Planning Submission For: (Strata Plan 67851) 'Marquis Apartments' at 200 William Street, Woolloomooloo.

Submission #2 - Revised Plans and Documents

Concept DA Proposal: D/2022/139 - 164-172, 174-194 William Street WOOLLOOMOOLOO NSW 2011 - 'Stage 1 concept proposal for a mixed-use development including a concept envelope up to a height of approximately 35m (RL59.99), indicative future residential and retail land uses, vehicular and loading access from Forbes Street, 4 indicative basement levels for parking, services and storage as well as provision of a publicly accessible through-site link off Dowling Street that connects to Judge Lane and Forbes Street.' (revised)

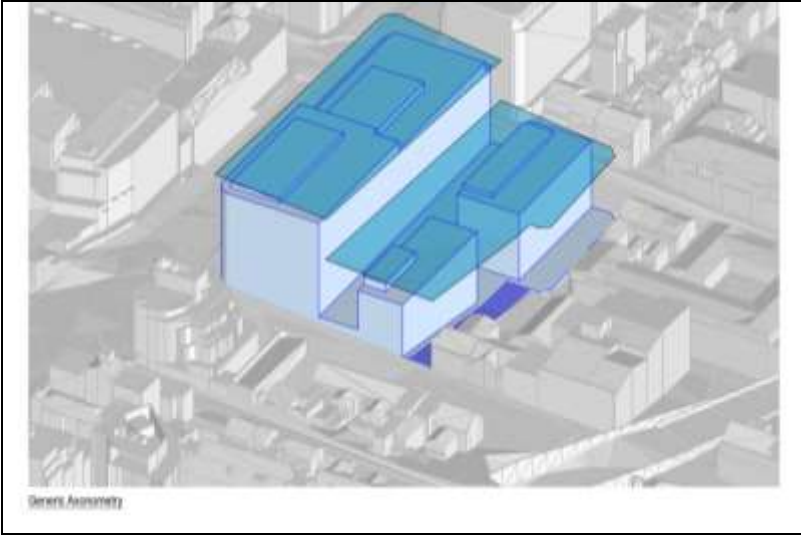
As detailed, the height is not considered appropriate to the condition of the site AND its context and does not provide transitions to the adjoining development or context. The scale would be incongruous.

A height of 22.6m in Judge Lane next to 12m height is not considered to provide a transition.

This can be seen in the montages provided of the reference scheme 'filling in' the proposed envelope. This photo montage which looks down from a **sky view** to the proposed enormous

building indicates the stark and incongruous height differences with lower prevailing forms. This graphic also shows the Marquis/Avis building dwarfed – to the top left. It is clear that the balconies and open spaces of the Marquis Apartments are directly impacted by the scale and block effect opposite.

By fjmt Studio Design Report – Proposed Montage showing the height of building relative to lower surrounding housing and forms & 196-200 William Street directly to the top left and over scaled.

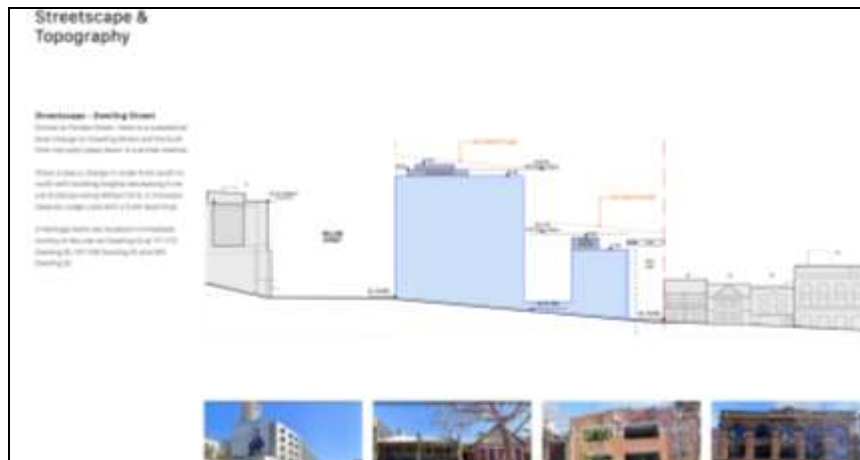
Extracts from the DA package/Design Report showing the height and scale of the form in the context of the much lower forms. The Avis residential building, shown bottom left corner is dwarfed. No detail is provided in the documentation as to what if anything this version does to any views from balconies.
